**TRAFFIC ENGINEERING AND OPERATIONS BULLETIN 17-01**  
**ROADWAY DESIGN BULLETIN 17-01**  
**(FHWA Approved: January 6, 2017)**

SUBJECT: Design Standards Index 17727 – Span Wire Traffic Signal Hangers

The following two **Design Standards Revisions (DSR)** are released:  
Revised FY 2016-17 Index 17727, (Signal Cable & Span Wire Installation Details); and  
Revised FY 2017-18 Index 17727, (Signal Cable & Span Wire Installation Details).

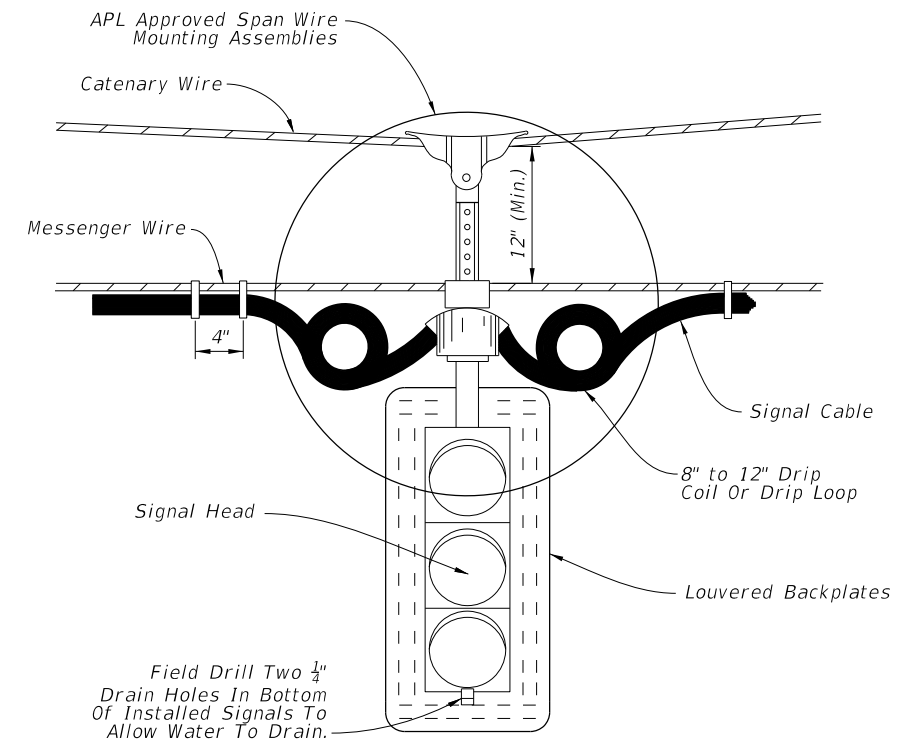
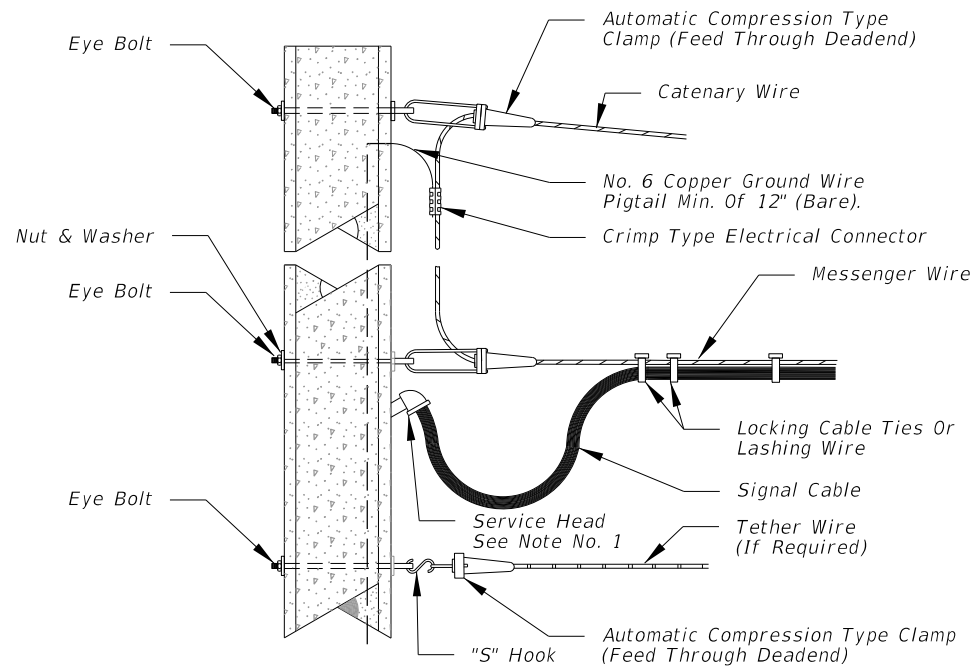
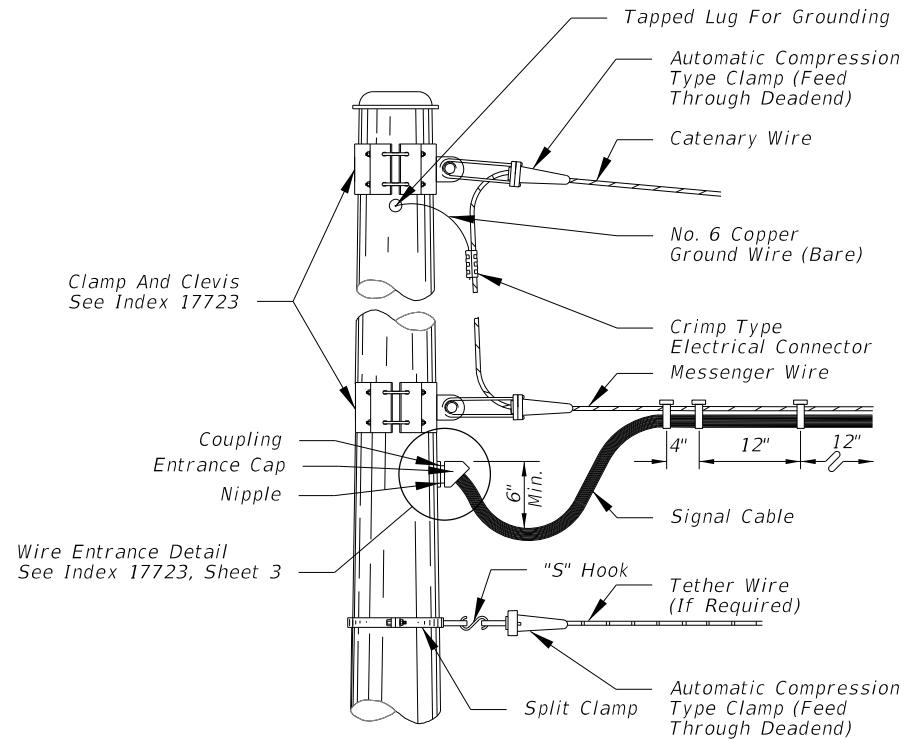
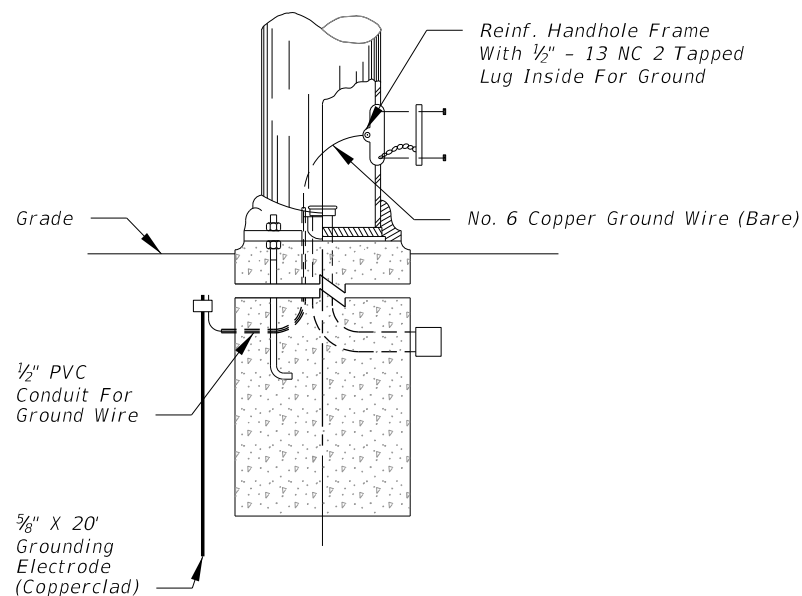
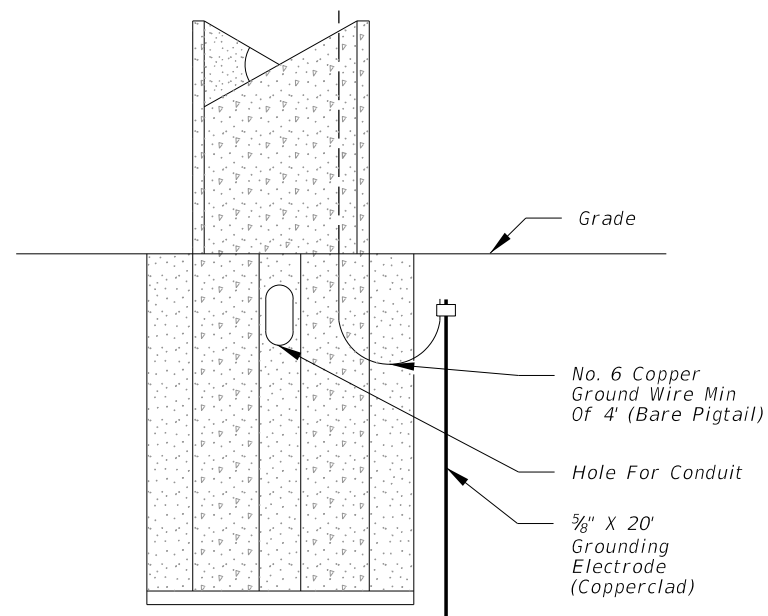
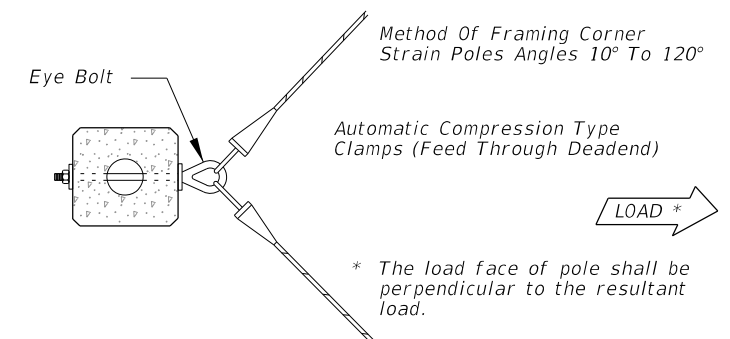
LAST REVISION 01/05/17	REVISION	DESCRIPTION: Sheet 1: Added Note #1; Moved SIGNAL ATTACHMENT details from Sheet 2. Sheet 2: Deleted Sheet.	 <b>FY 2016-17 DESIGN STANDARDS</b>	<b>SIGNAL CABLE &amp; SPAN WIRE INSTALLATION DETAILS</b>	INDEX NO. <b>17727</b>	SHEET NO. <b>1 of 1</b>
------------------------------	----------	--	--	--	------------------------------	-------------------------------

1. Use only span wire mounting assemblies listed on the APL. For specific details and requirements, see the vender drawings on the APL.
2. With the approval of the resident engineer, the service head hole for joint use poles may be drilled by the utility company at an angle of 90° but not less than 45° to the face of the pole.
3. Lashing wire should normally be used for distances of 12' or greater.
4. All hardware for signal attachment shall be stainless steel.
5. Hole for eye bolt will require field reaming for 1" & 1 1/4" eye bolts.
6. Meet all grounding requirements of Specification 620.

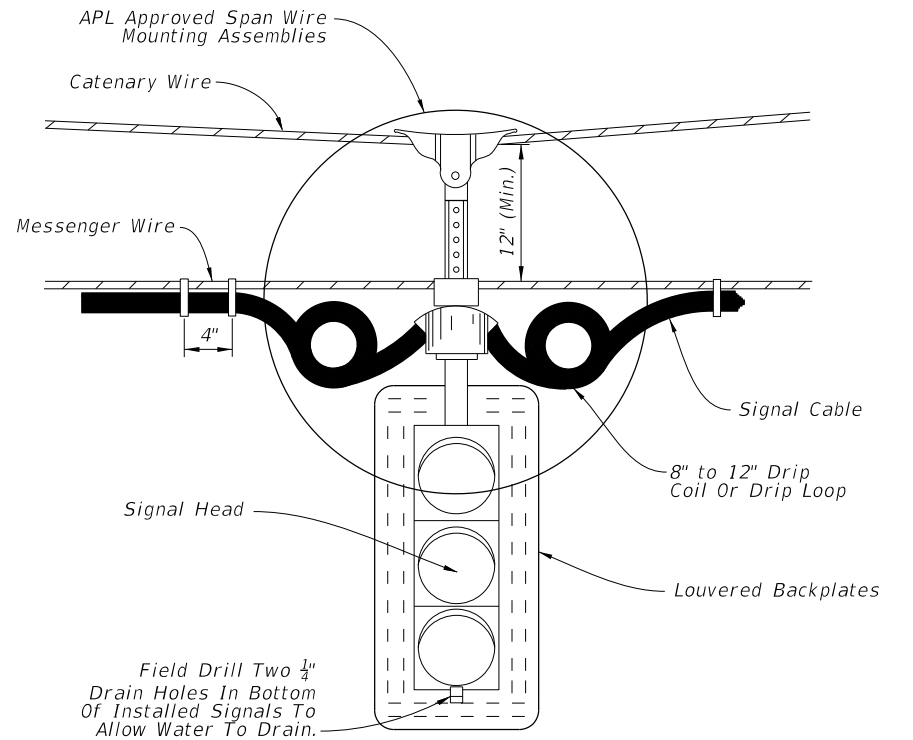
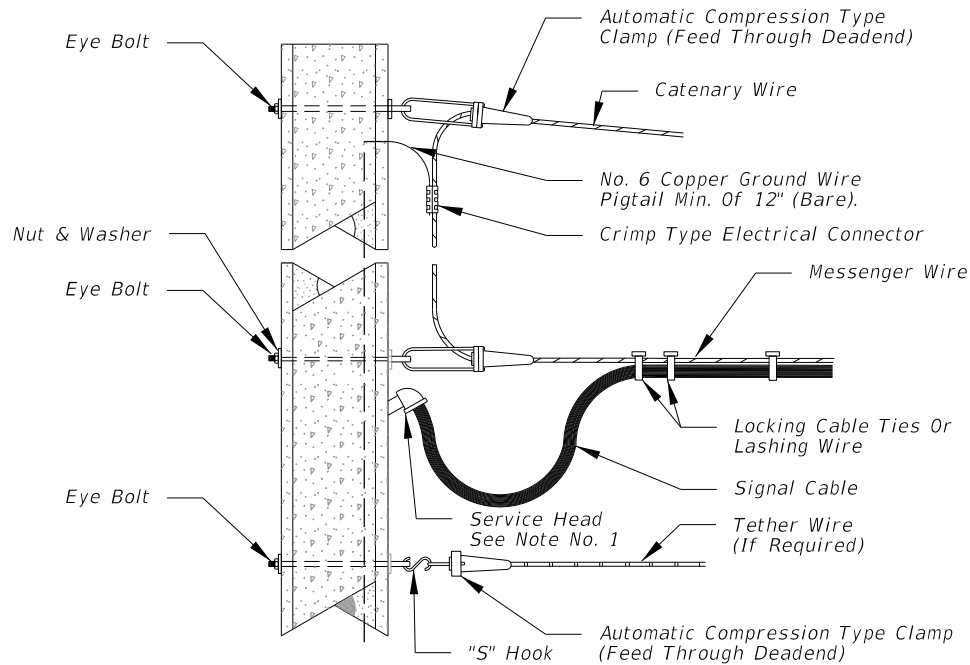
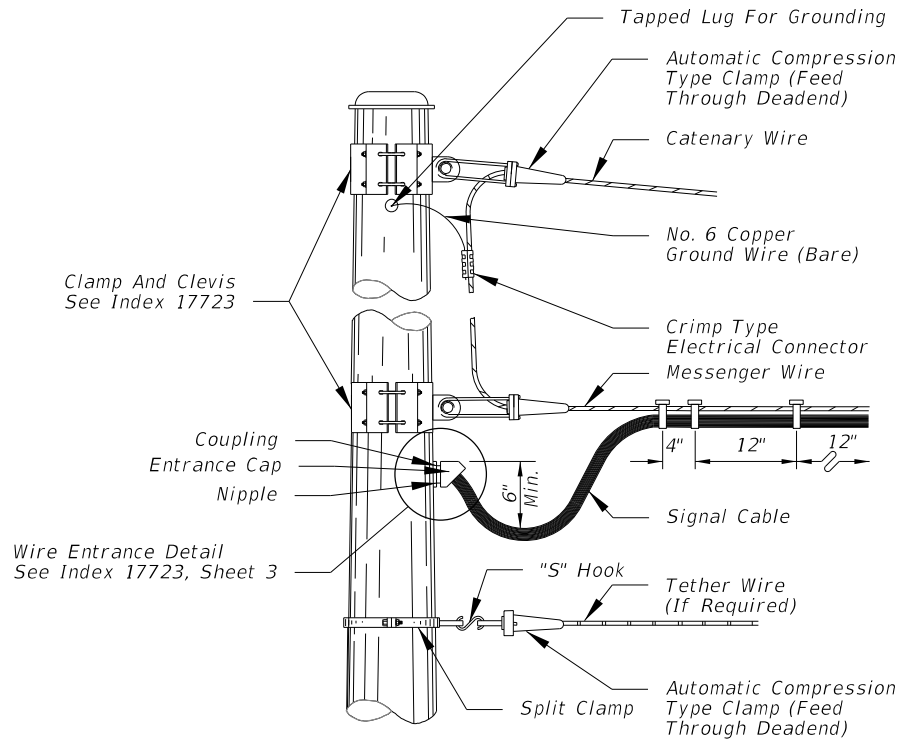
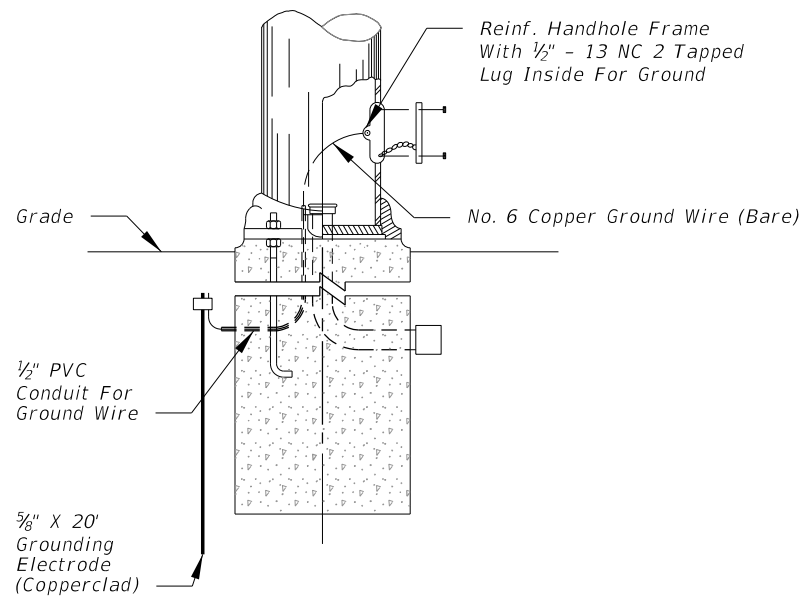
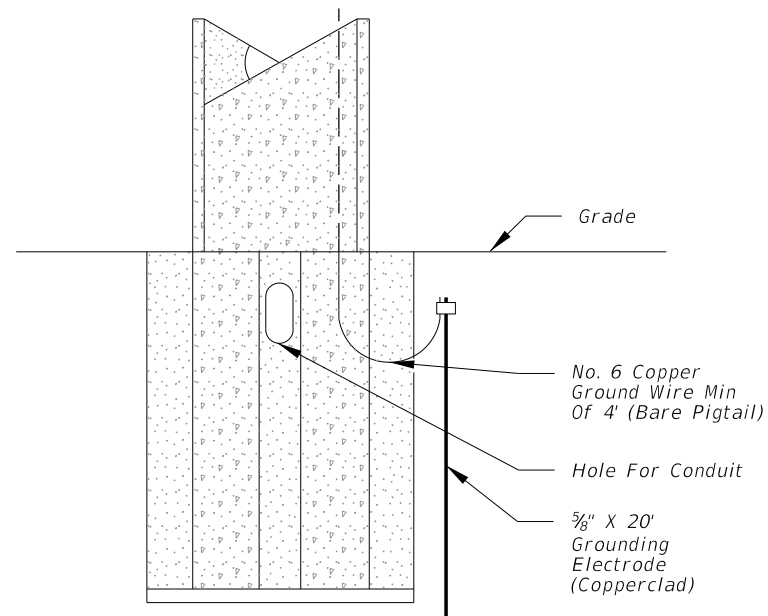
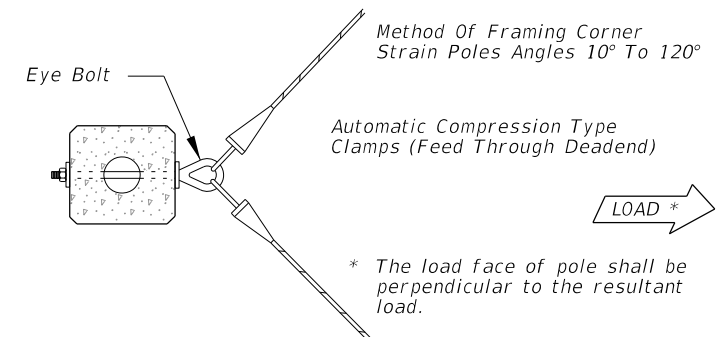
LAST REVISION 01/05/17	REVISION	DESCRIPTION: Sheet 1: Added Note #1; Moved SIGNAL ATTACHMENT details from Sheet 2. Sheet 2: Deleted Sheet.	 <b>FY 2017-18 DESIGN STANDARDS</b>	<b>SIGNAL CABLE &amp; SPAN WIRE INSTALLATION DETAILS</b>	INDEX NO. <b>17727</b>	SHEET NO. <b>1 of 1</b>
------------------------------	----------	--	--	--	------------------------------	-------------------------------

1. Use only span wire mounting assemblies listed on the APL. For specific details and requirements, see the vender drawings on the APL.
2. With the approval of the resident engineer, the service head hole for joint use poles may be drilled by the utility company at an angle of 90° but not less than 45° to the face of the pole.
3. Lashing wire should normally be used for distances of 12' or greater.
4. All hardware for signal attachment shall be stainless steel.
5. Hole for eye bolt will require field reaming for 1" & 1 1/4" eye bolts.
6. Meet all grounding requirements of Specification 620.
